# THE GLEN AT WIDEFIELD FILING NO. 10

## RESIDENTIAL SUBDIVISION CONSTRUCTION DRAWINGS

February 12, 2020  
PCD File No. SF-1921

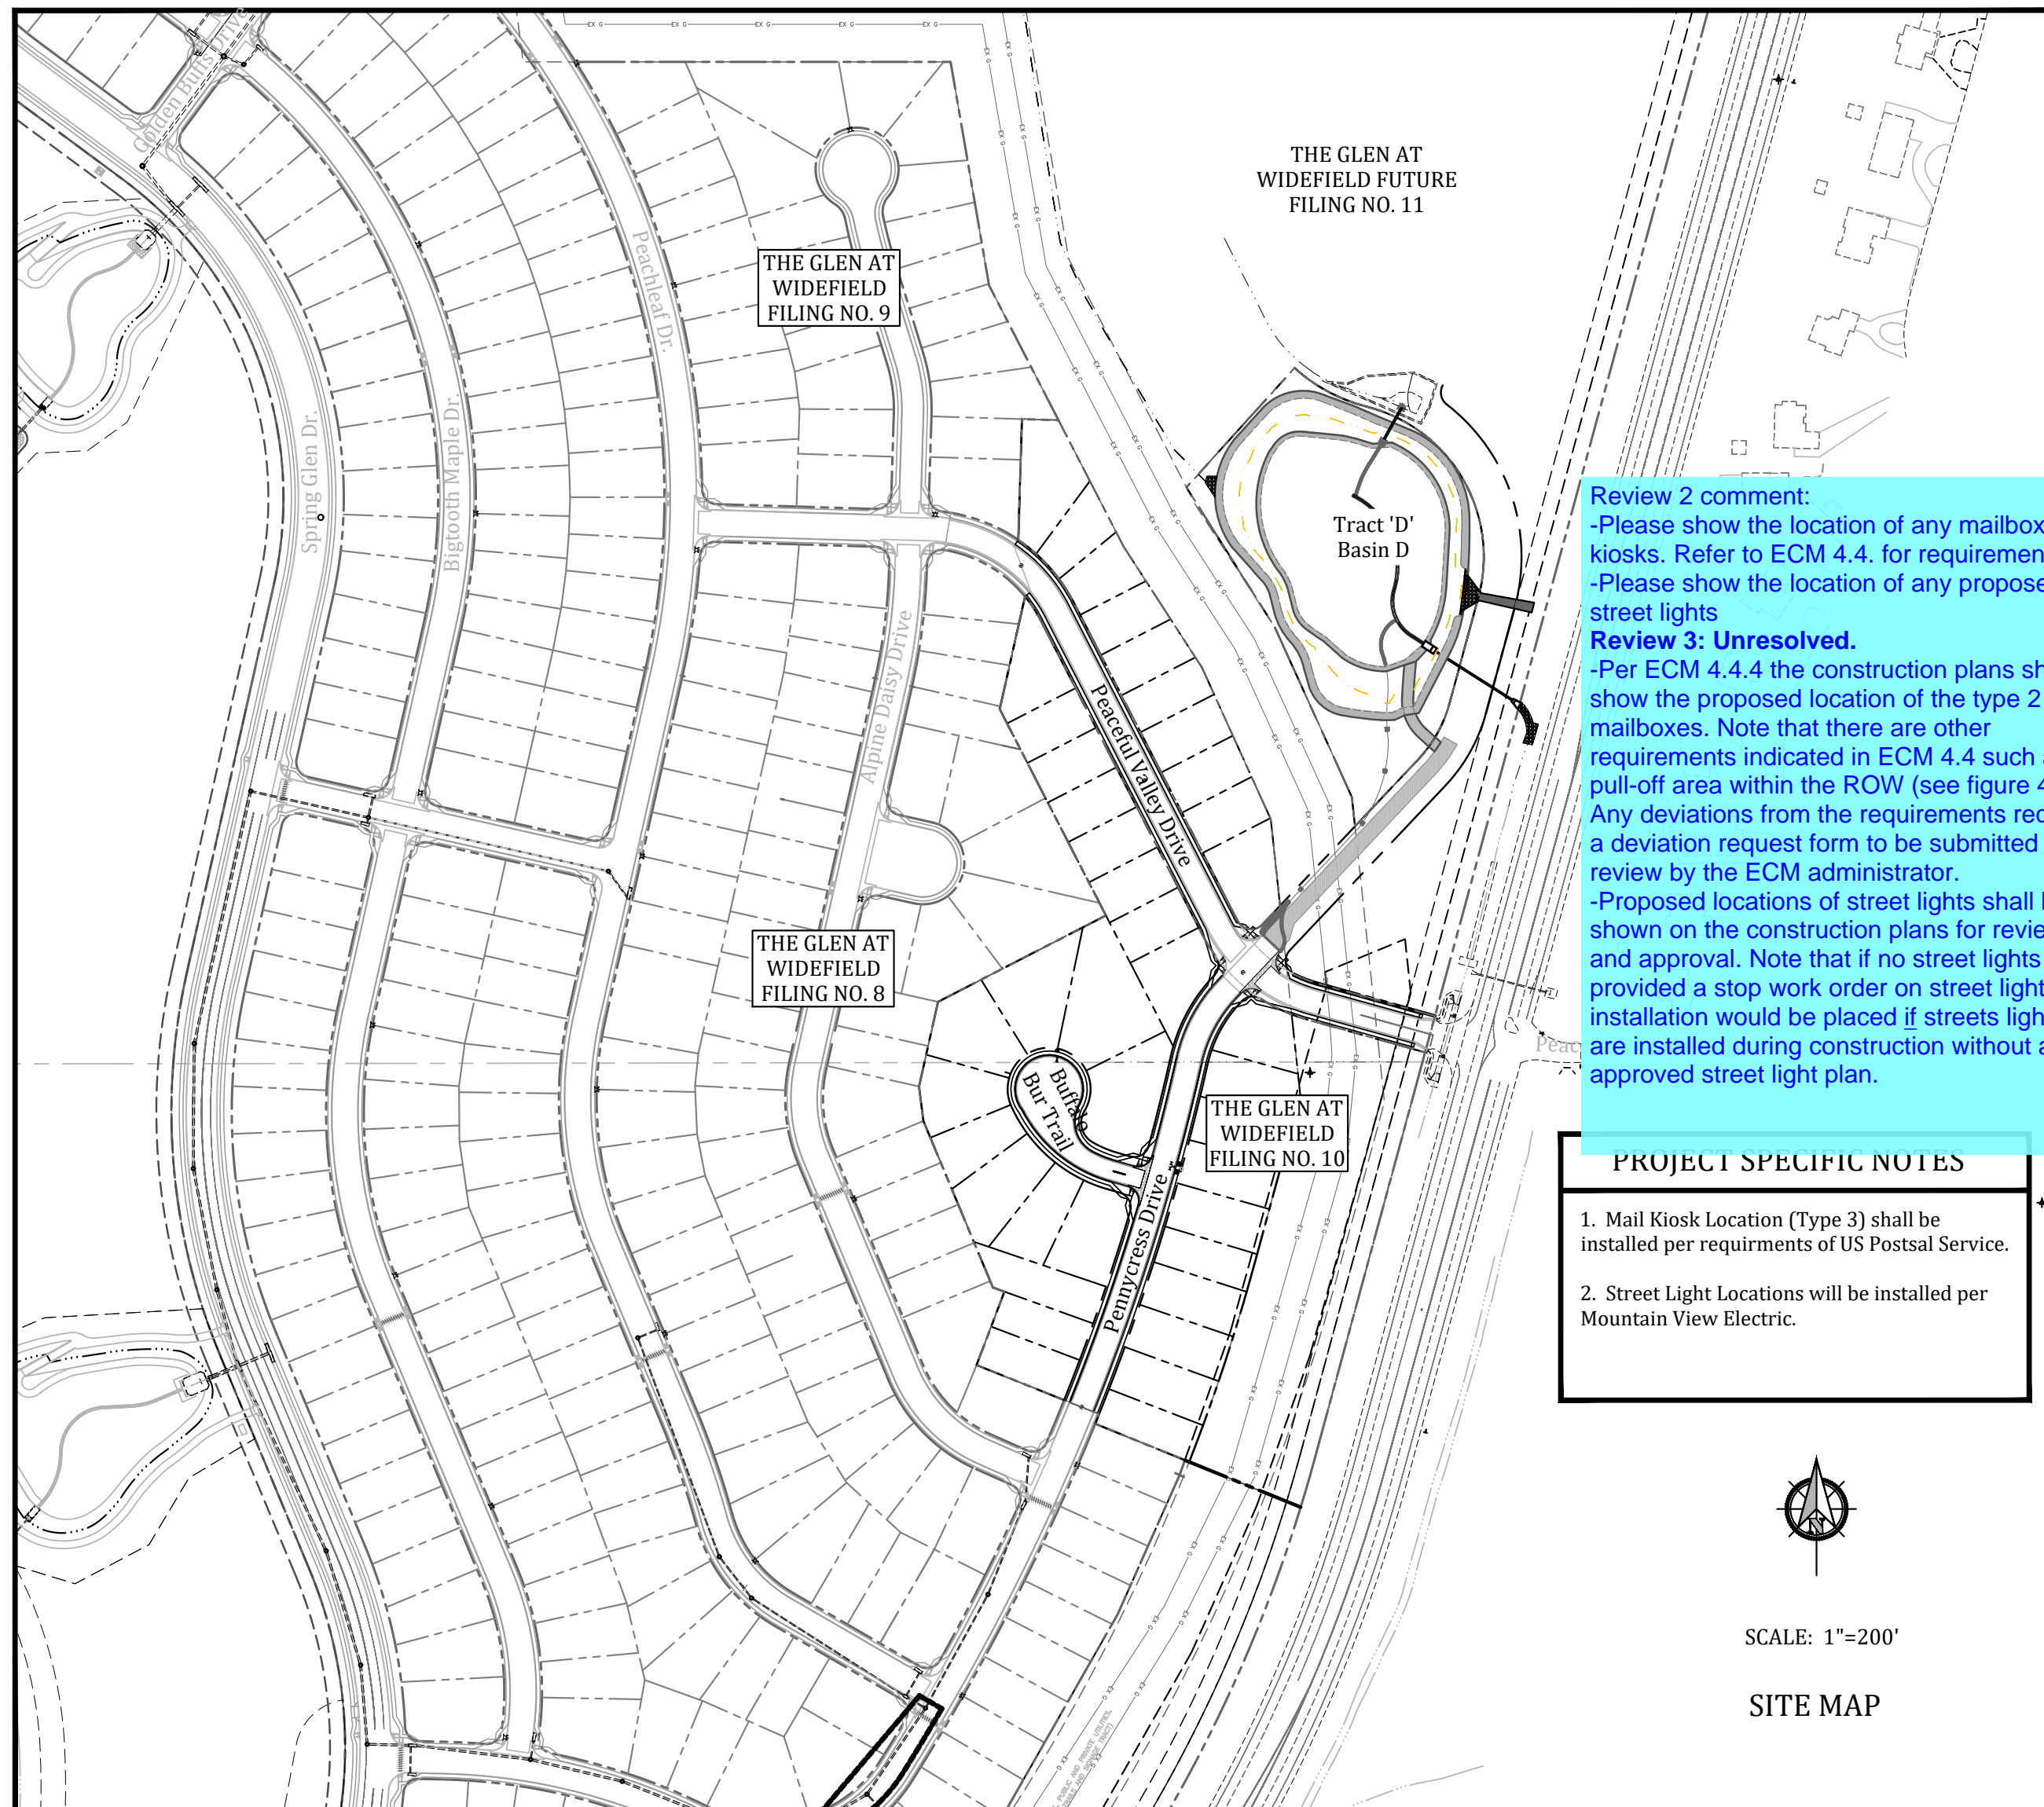
Review 2 comment:  
The TIS provides recommendations for improvements at these intersections. Coordinate with the traffic engineer as to the timing of these improvements and provide the appropriate construction documents for review in the re-submittal.  
Review 3: Unresolved.  
TIS indicates that with this filing improvements are required. Please provide the appropriate documents for review with the re-submittal

GLEN AT WIDEFIELD NO. 10  
SIGNING & STRIPING PLAN

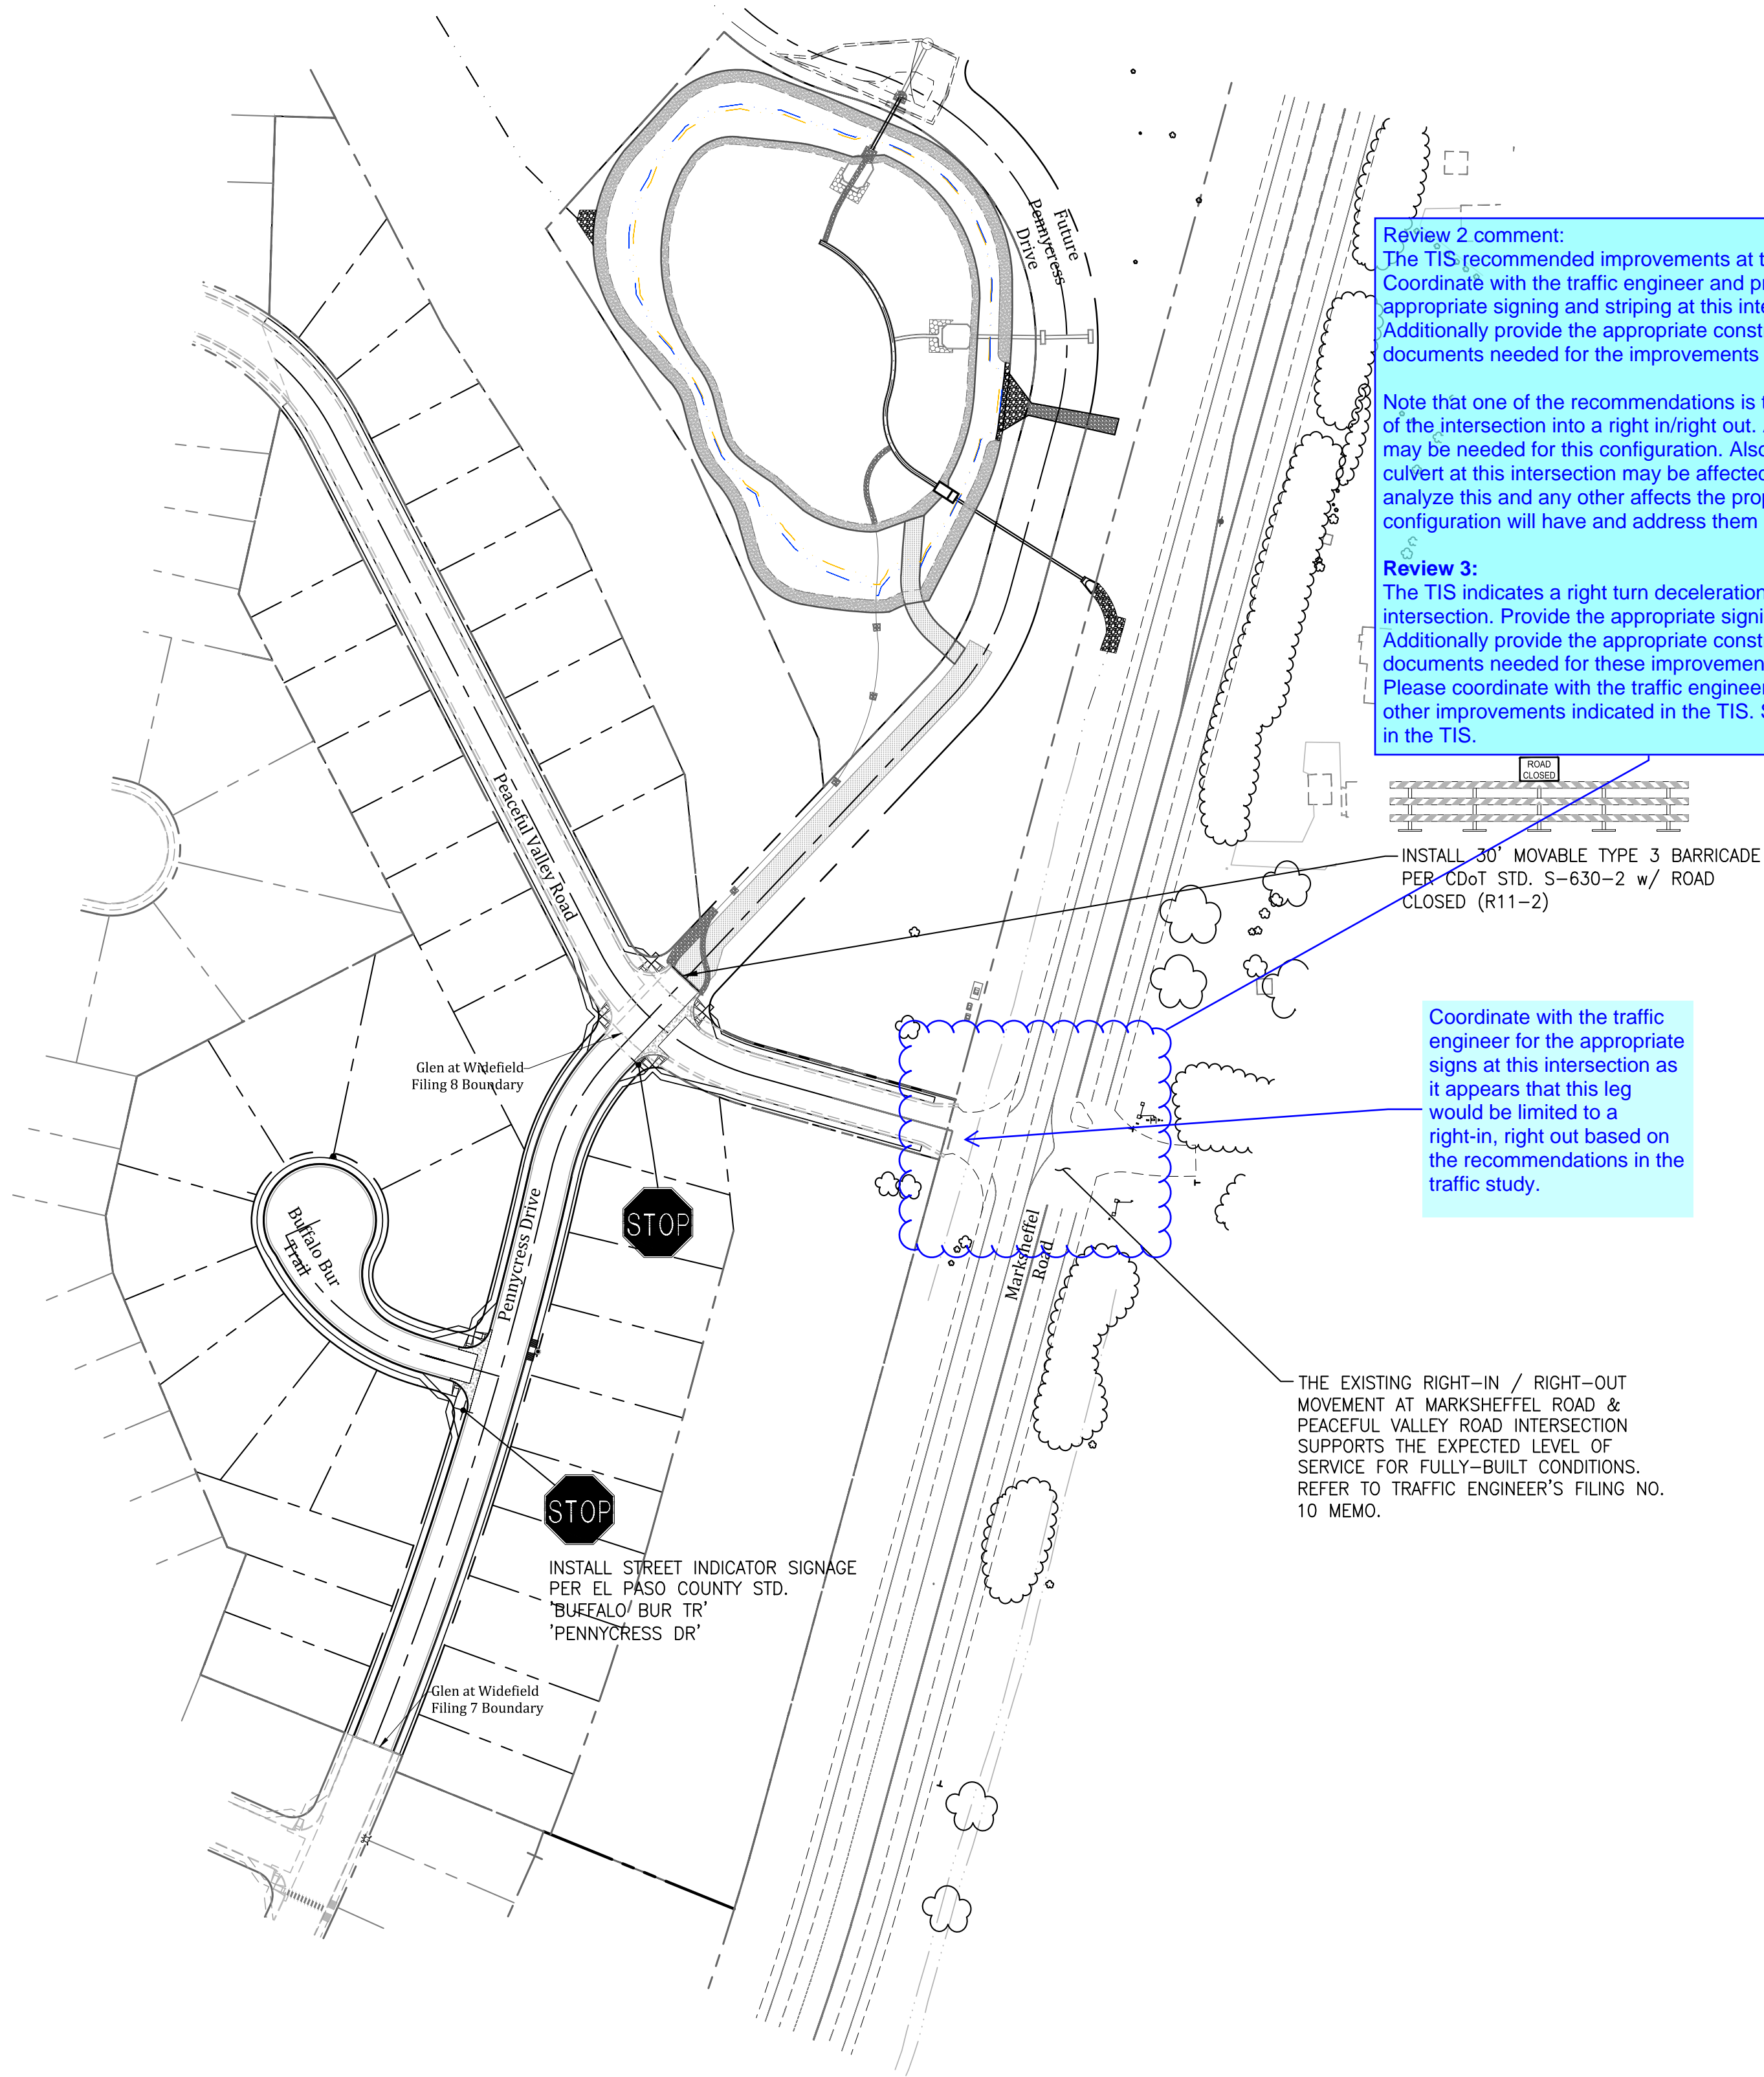
**Review 2 comment:**  
The TIS recommended improvements at this intersection. Coordinate with the traffic engineer and provide the appropriate signing and striping at this intersection. Additionally provide the appropriate construction documents needed for the improvements recommended.

Note that one of the recommendations is to revise this leg of the intersection into a right in/right out. Additional ROW may be needed for this configuration. Also the current culvert at this intersection may be affected. Be sure to analyze this and any other affects the proposed configuration will have and address them accordingly.

**Review 3:**  
The TIS indicates a right turn deceleration lane at this intersection. Provide the appropriate signing/striping. Additionally provide the appropriate construction documents needed for these improvements for review. Please coordinate with the traffic engineer regarding other improvements indicated in the TIS. See comments in the TIS.
